Access Compliance Report

Public Rights-of-Way

(Curb Ramps)

Intersection ID: N/A	Main Street: TYVOLA_RD	Cross Street: SPEER_BV	Location: E
ADA ID: 82F9F7FA5E02	Ramp Type: Perp	Initial Pass/Fail: Fail	Overall Compliance: No
		Severity Score: 12.5

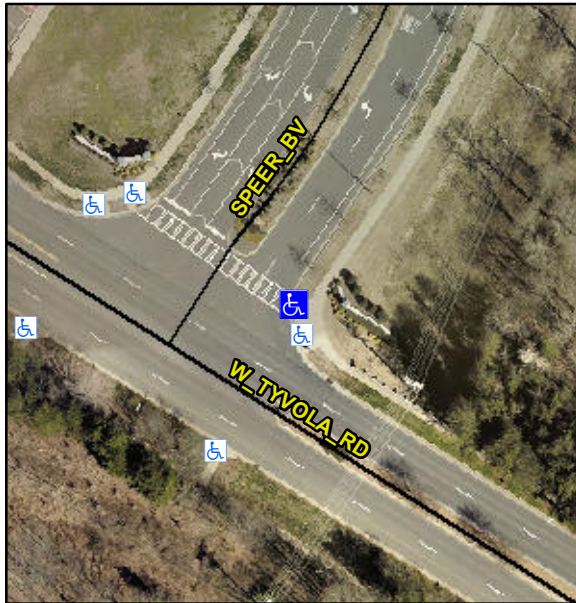
Not Found, R304.5.3

Compliance	Description	Data	Compliance	Description	Data
N/A	Ramp Length (in)	92.5	Yes	Ramp Slope (%)	8.1
Yes	Ramp Width (in)	70.5	No	Ramp XSlope (%)	5.5
N/A	Flare Type LT	N/A	N/A	Flare Type RT	N/A
N/A	Flare Slope LT (%)	N/A	N/A	Flare Slope RT (%)	N/A
N/A	Flare Traversable LT?	N/A	N/A	Flare Traversable RT?	N/A
N/A	Landing Length (in)	N/A	N/A	DWS Provided?	N/A
N/A	Landing Width (in)	N/A	N/A	DWS Contrast?	N/A
N/A	Landing Slope (%)	N/A	N/A	DWS Length (in)	N/A
N/A	Landing X Slope (%)	N/A	N/A	DWS Full Width?	N/A
N/A	Landing Curb? (Y/N)	N/A	N/A	DWS Offset (in)	N/A
N/A	Shared Landing?	N/A			
N/A	Gutter Ponding?	N/A	N/A	Gutter Slope (%)	N/A
N/A	Gutter Lip Ht (in)	N/A	N/A	Gutter X Slope (%)	N/A
N/A	Painted X Walk1?	Yes	N/A	Painted X Walk2?	N/A
	X Walk 1 Direction	To NW		X Walk 2 Direction	N/A
N/A	X Walk 1 Width (in)	113.0	N/A	X Walk 2 Width (in)	N/A
	X Walk 1 Slope (%)	2.7		X Walk 2 Slope (%)	N/A
	X Walk 1 X Slope (%)	4.8		X Walk 2 X Slope (%)	N/A

Remove & Replace Entire Ramp.
